### **ADDENDUM NO. 3**

Date: **03/23/23**

Issued by: **Sacramento City Unified School District**

Project: **Project #0168-418 John D. Sloat ES Paving, Playground, and Fencing Project**

KEY PLAN:  
 SHEET TITLE:  
 → **OVERALL ARCHITECTURAL SITE DEMOLITION PLAN**

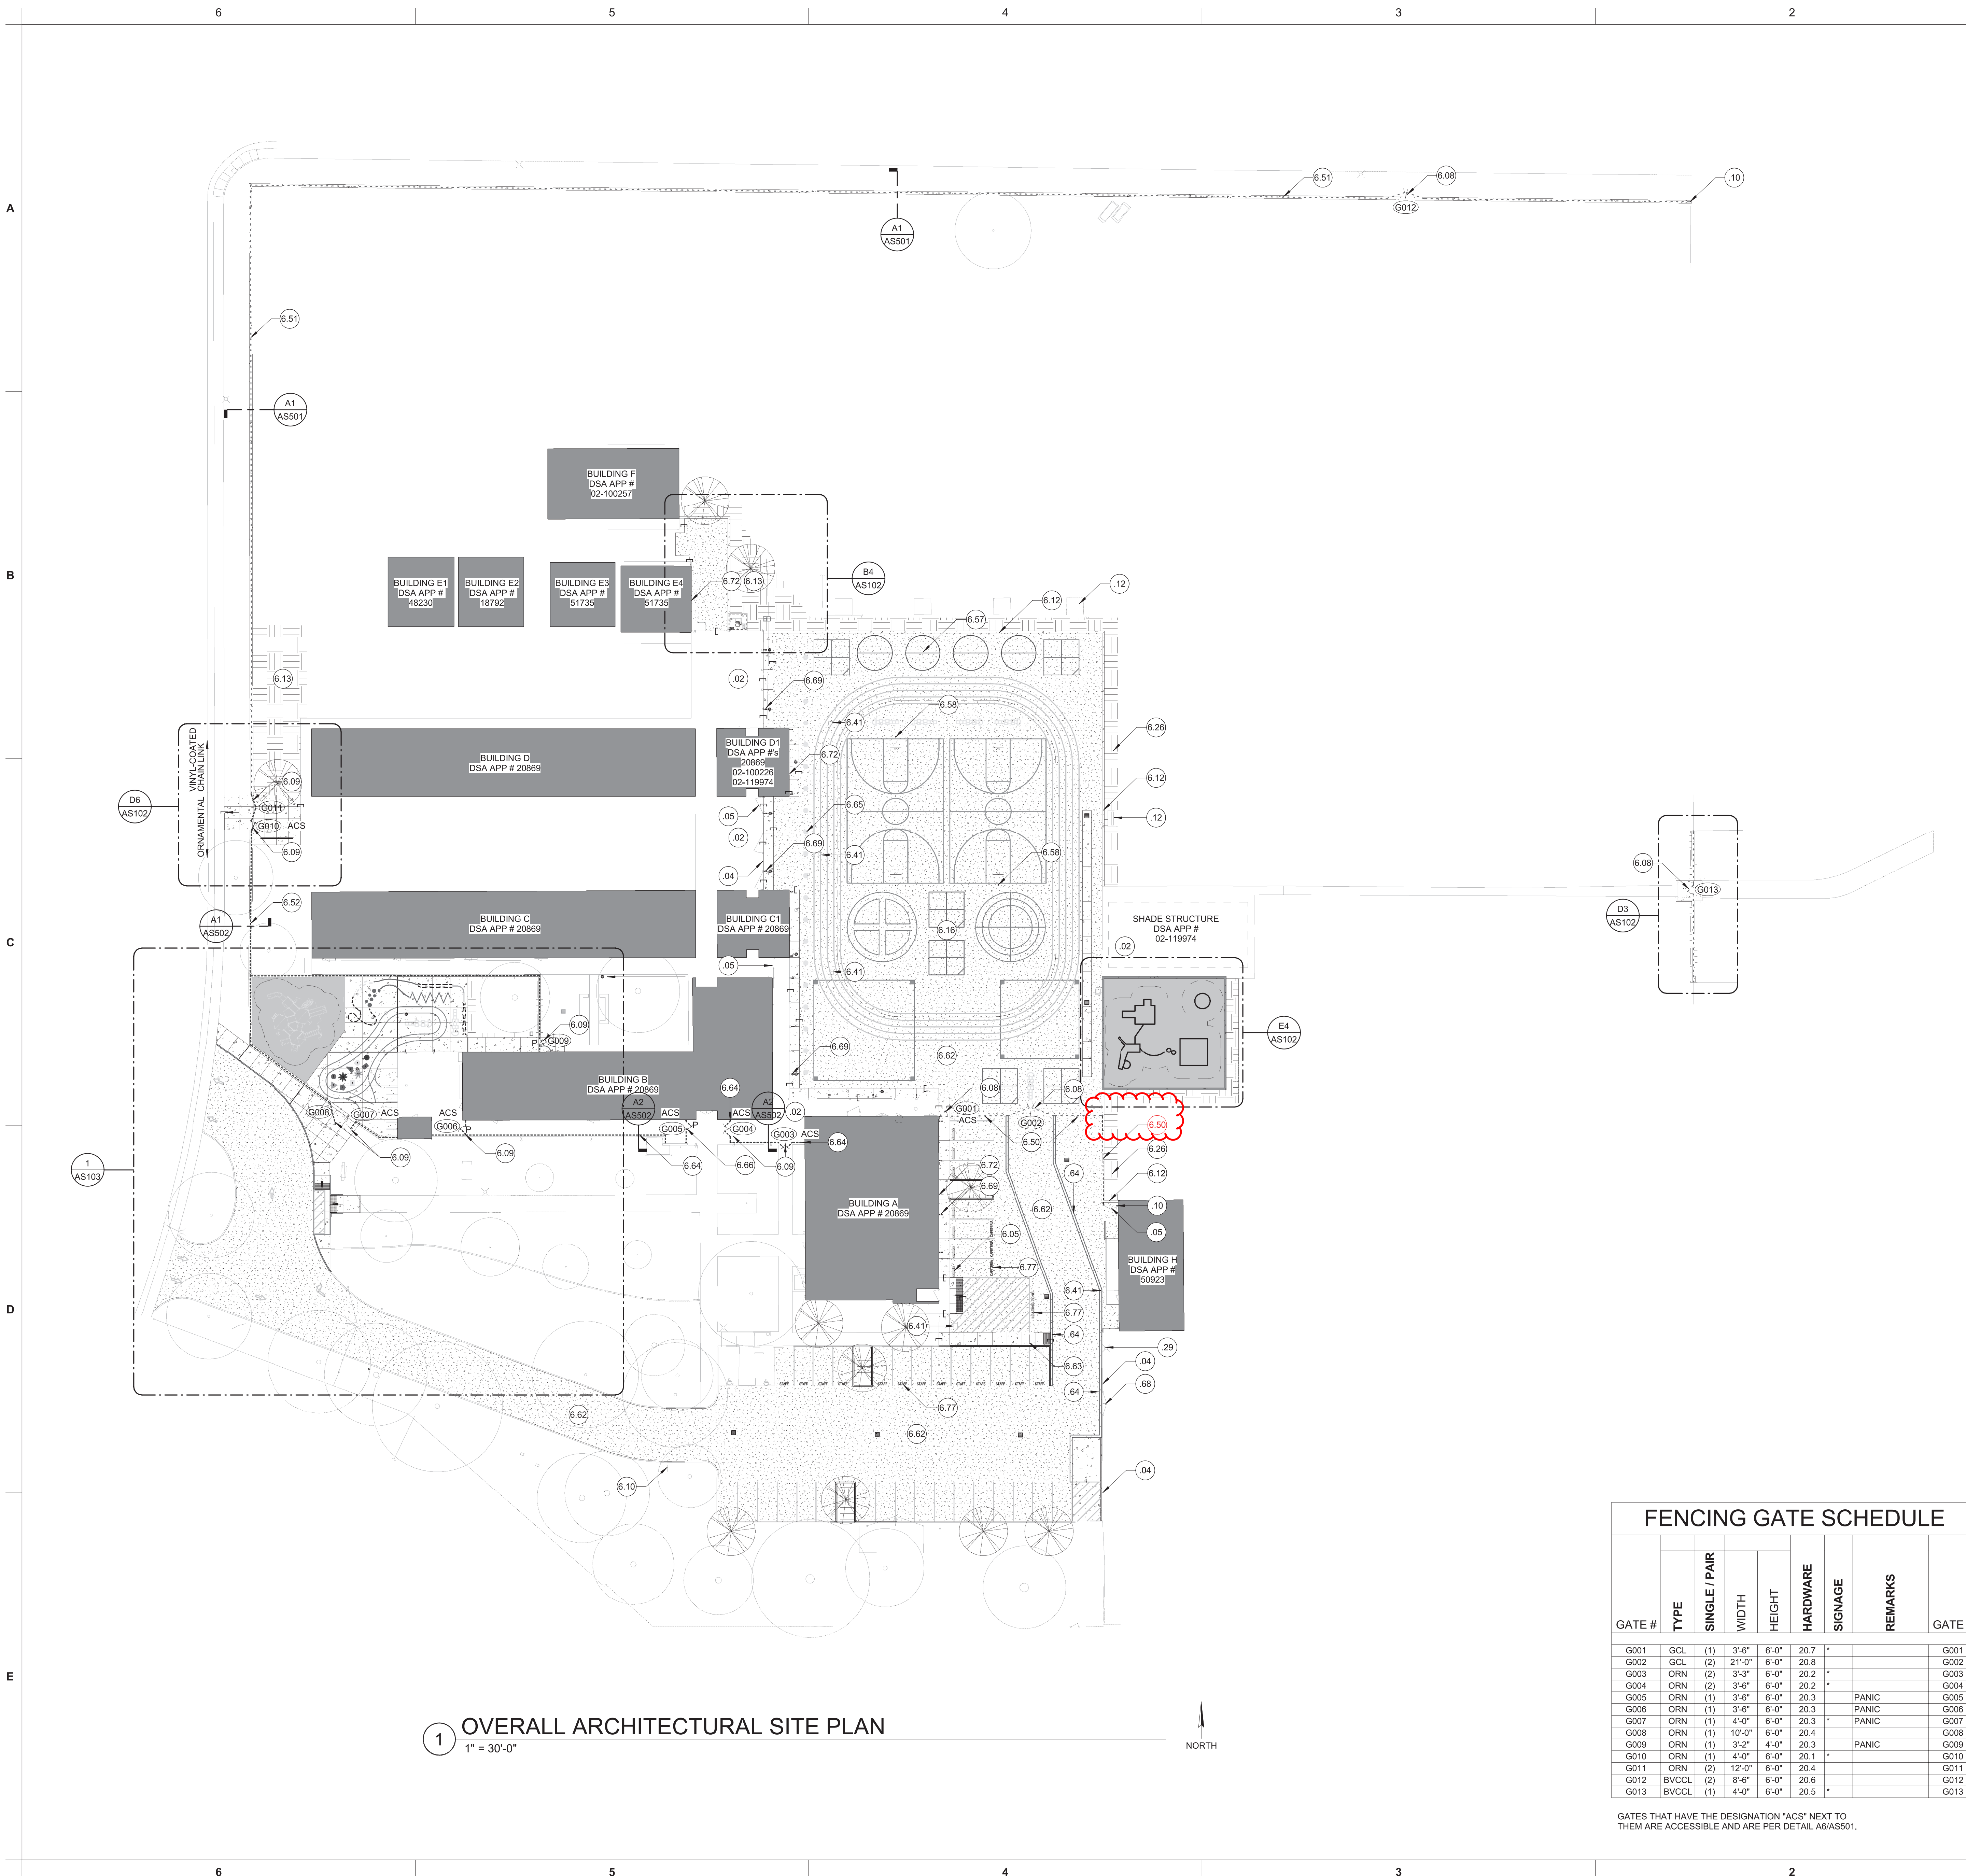
- AD03.07 Sheet AS98 – Overall Architectural Site Demolition Plan: Refer to the attached **ADD3 AS98**. All changes are clouded in red. Changes are to the fencing adjacent the play area on the north side of the site.

- A3: **Refer to response in Addendum # 3, above.**
- Q4: There demo of the fence callout for notes #.10 and #.31 on sheet AS98 indicates to leave the fence posts in place but remove fabric between Building A & H and the play area. We highly recommend the call out to be revised the demolition of the fence/posts and replacement. This will create an obstacle for all work included the ability to complete the lime treatment in an efficient and effective manner. More importantly, the excavation to finish subgrade and the mixing of the lime treatment will leave more than 50% of the fence post footings without compacted soil adjacent and not structurally able to support the fence properly during construction. Please revise this to remove the fence and to replace as that is the only realistic way to perform the work and provide a quality product.

- .21 REMOVE / DEMOLISH ALL (E) WOOD CHIP FALL PROTECTION. GRADE FOR NEW WORK. REFER TO CIVIL.
- .31 REMOVE AND PROTECT (E) CHAIN-LINK FENCING FABRIC TO ALLOW FOR INSTALLATION OF NEW CONCRETE CURB BELOW. PROTECT POSTS TO REMAIN. REINSTALL FABRIC AFTER PAVING WORK IS COMPLETE. PROVIDE ALL NEW TIES AND TENSION WIRE.

KEY PLAN:  
SHEET TITLE:  
**OVERALL ARCHITECTURAL SITE PLAN**

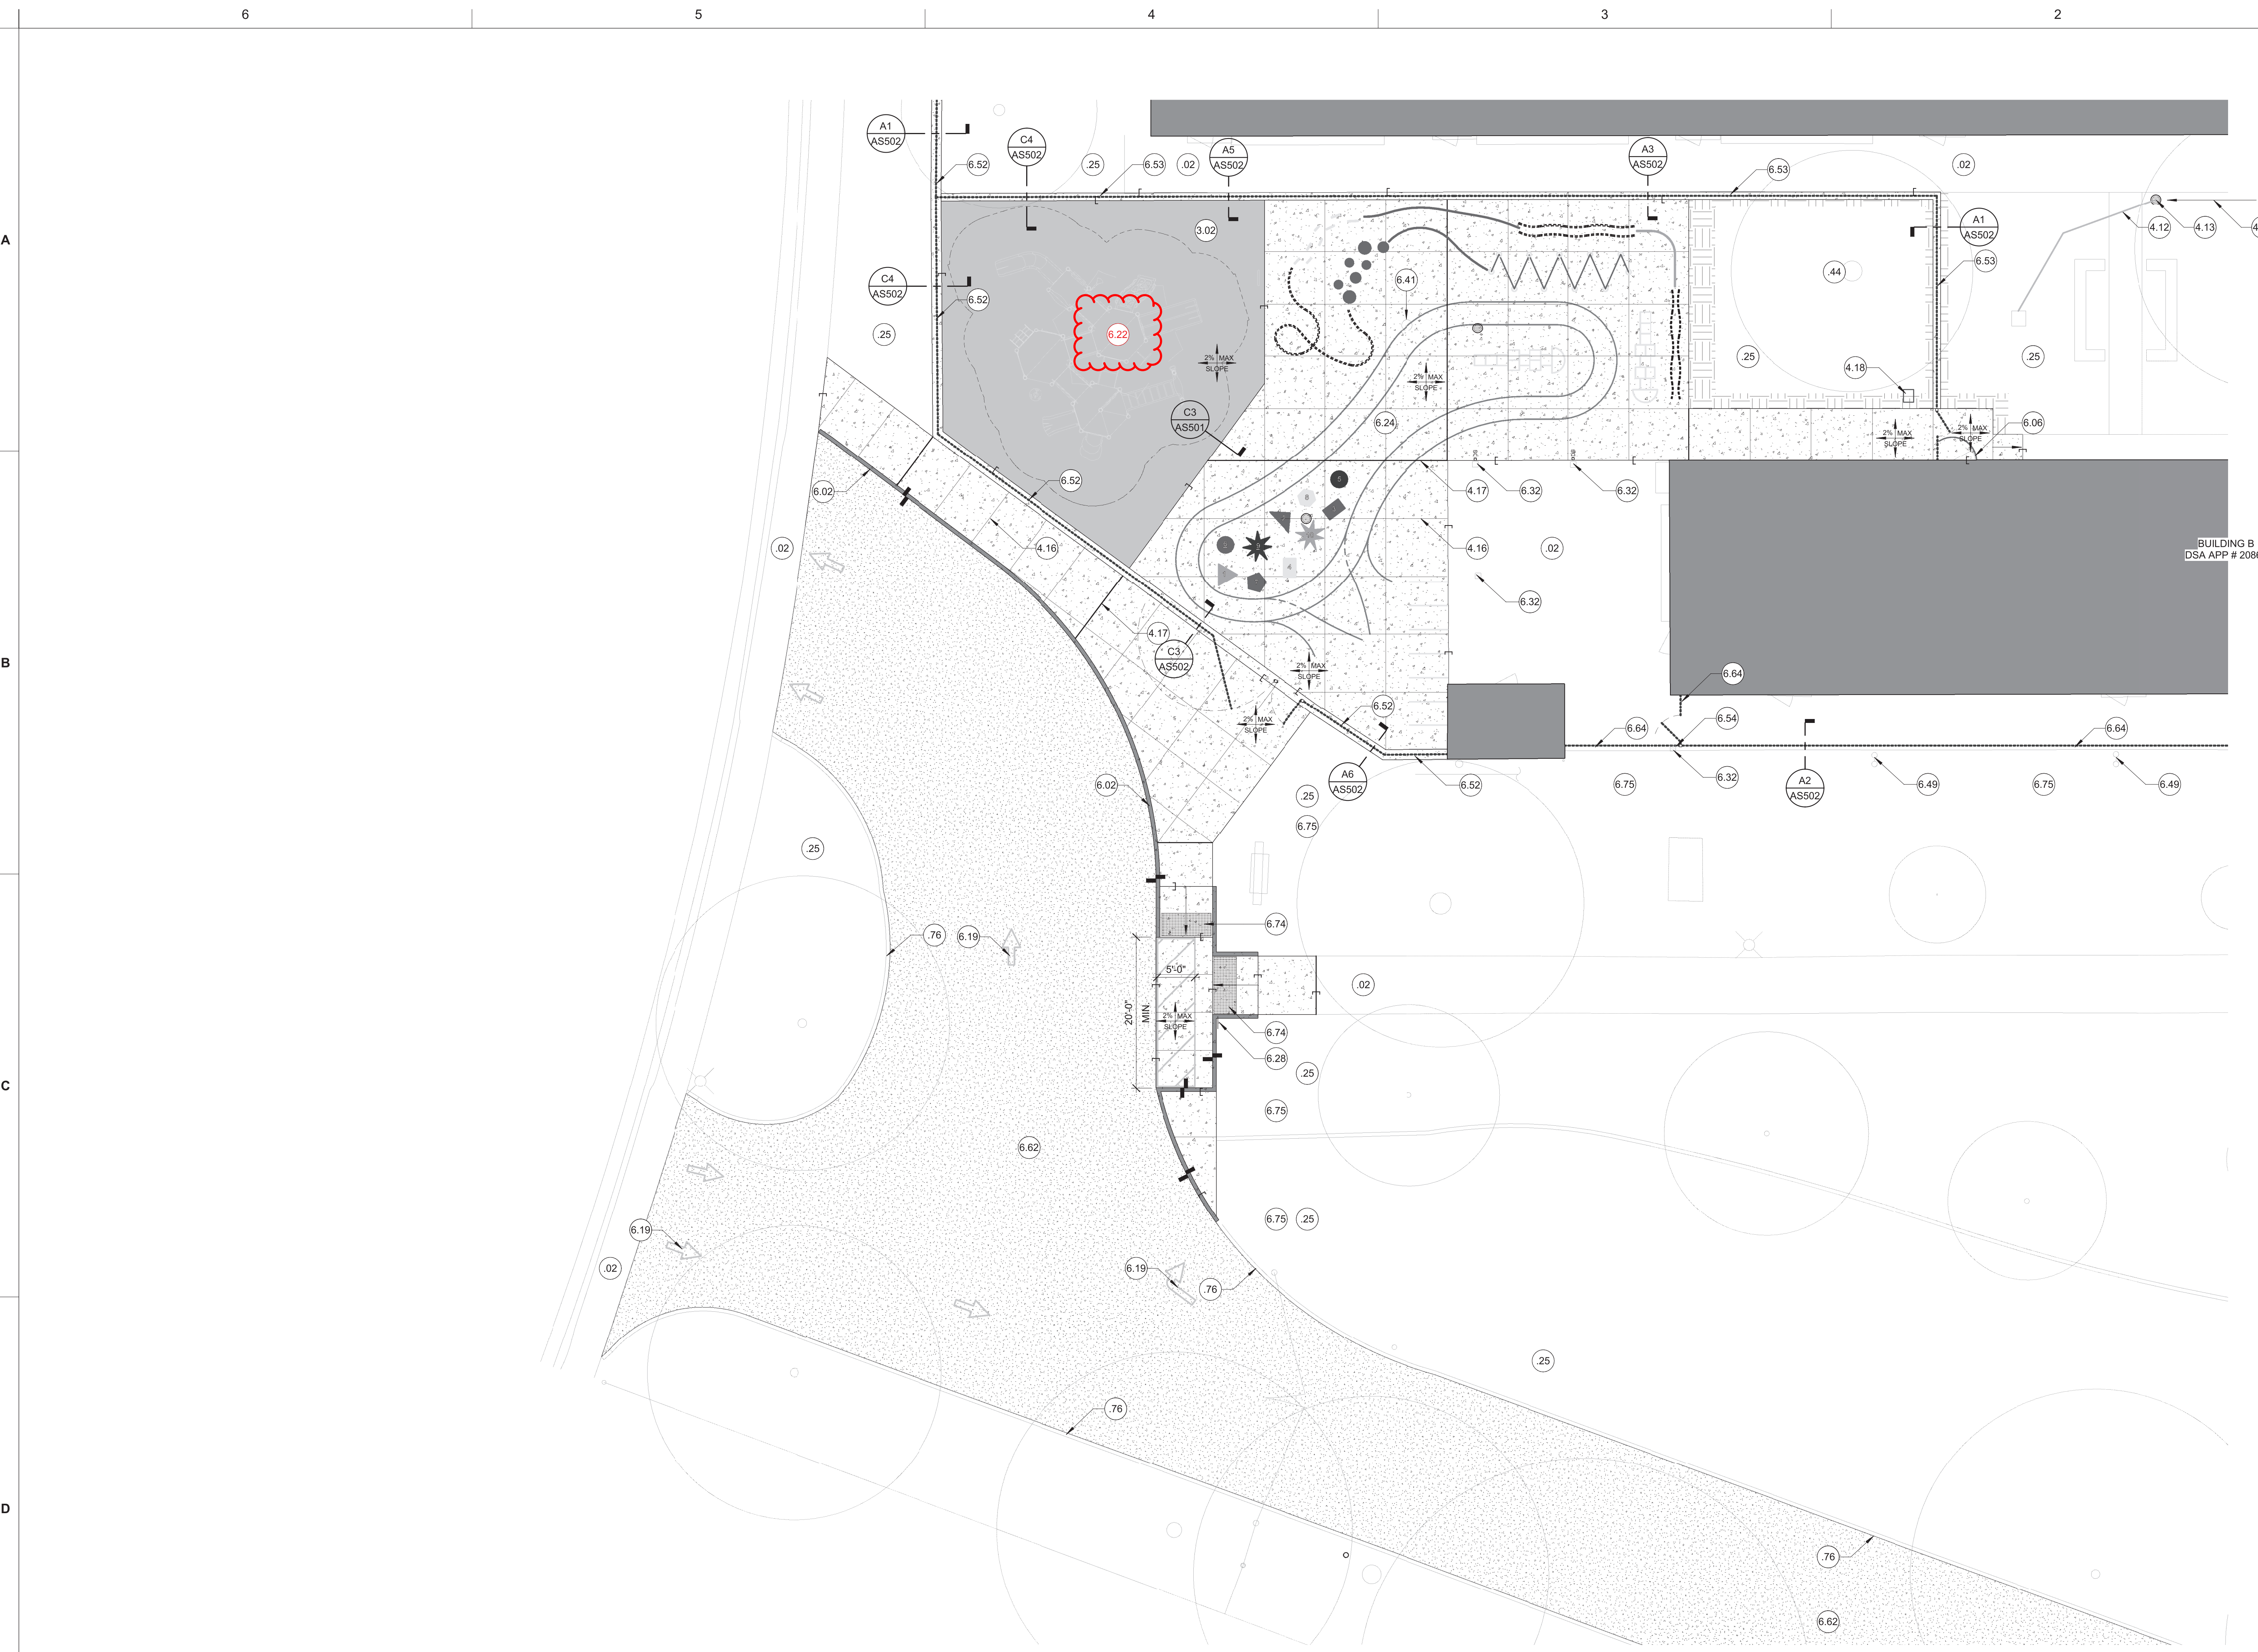
- AD03.08 Sheet AS100 – Overall Architectural Site Plan: Refer to the attached **ADD3 AS98**. All changes are clouded in red. Changes are to the fencing adjacent the play area on the north side of the site.

SHEET TITLE:  
**KINDER AREA  
ENLARGED ARCH'L  
SITE PLAN**

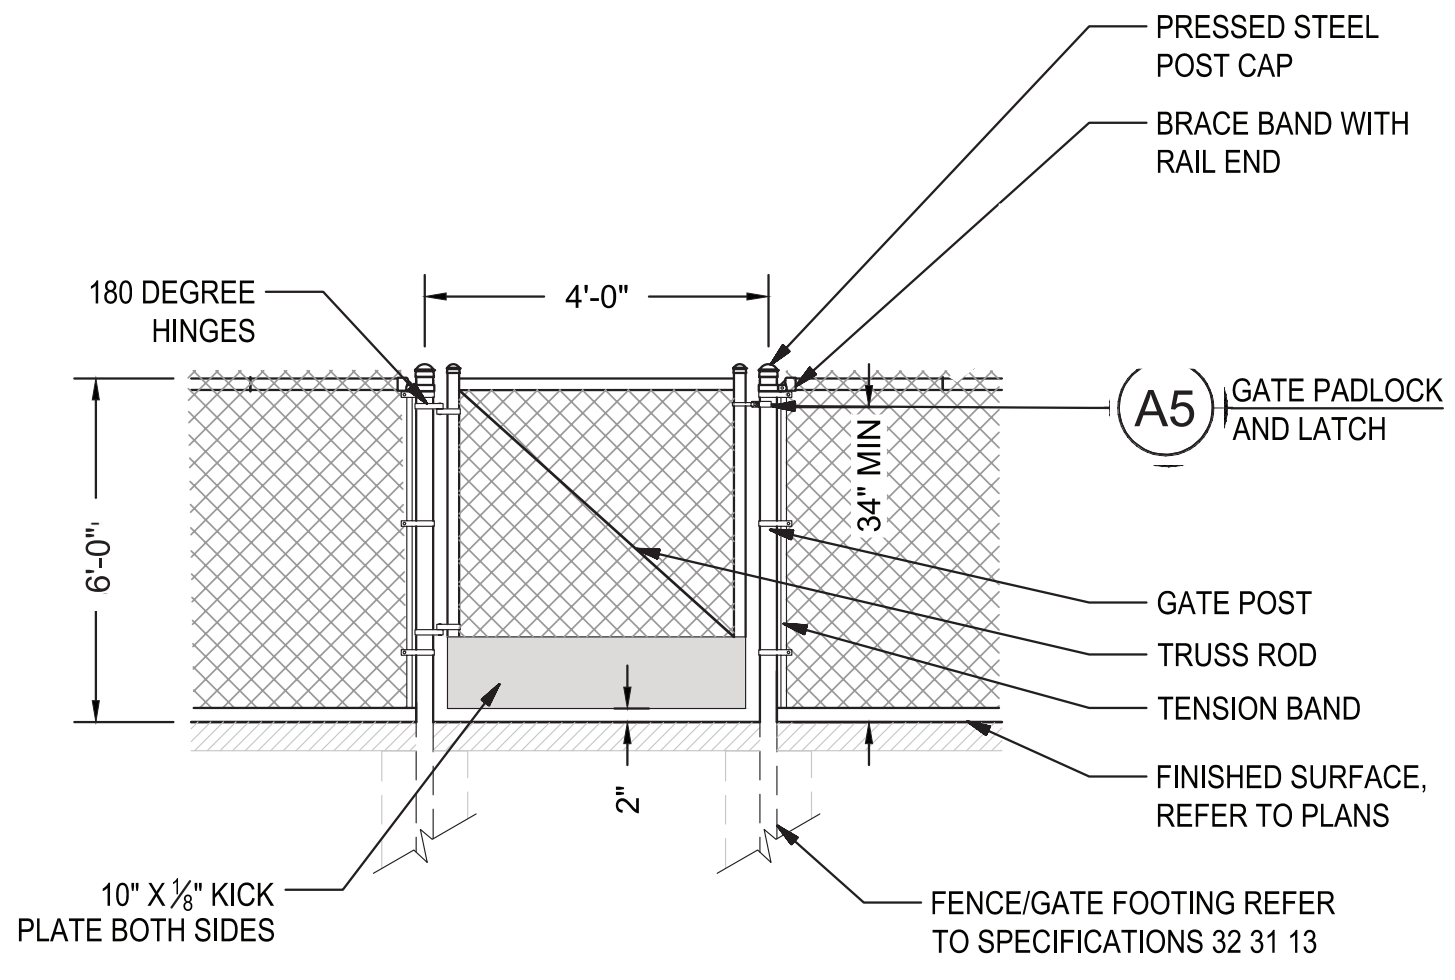
- AD03.09 Sheet AS103 – Kinder Area – Enlarged Architectural Site Plan: Refer to the attached **ADD3 AS103**. All changes are clouded in red. Changes are to Keyed Note 6.22, which is located in the Kindergarten Play Area. **General Contractor to furnish and install new play structure assembly and components in Kindergarten Play Area. Manufacturer of Play Equipment is Park Planet. Play Structure Model is R50BF134A. General Contractor to also provide Age Sign (2-12), Model A2-1304. Contact: Kyle Knox at Park Planet. 877.473.7619 (Office), 541.315.001 (Mobile), [kyle@parkplanet.com](mailto:kyle@parkplanet.com).**

- 6.22 NEW PLAY STRUCTURE ASSEMBLY AND COMPONENTS SHALL BE FURNISHED AND INSTALLED BY THE GENERAL CONTRACTOR. PLAY STRUCTURE SHALL COMPLY WITH USC 118-1009. MANUFACTURER OF PLAY EQUIPMENT IS PARK PLANET. PLAY STRUCTURE MODEL IS R50BF134A. ALSO PROVIDE AGE SIGN (2-12), MODEL A2-1304. CONTACT: KYLE KNOX, PARK PLANET, 877-473-7619 (OFFICE), 541-315-0611 (MOBILE), KYLE@PARKPLANET.COM.**
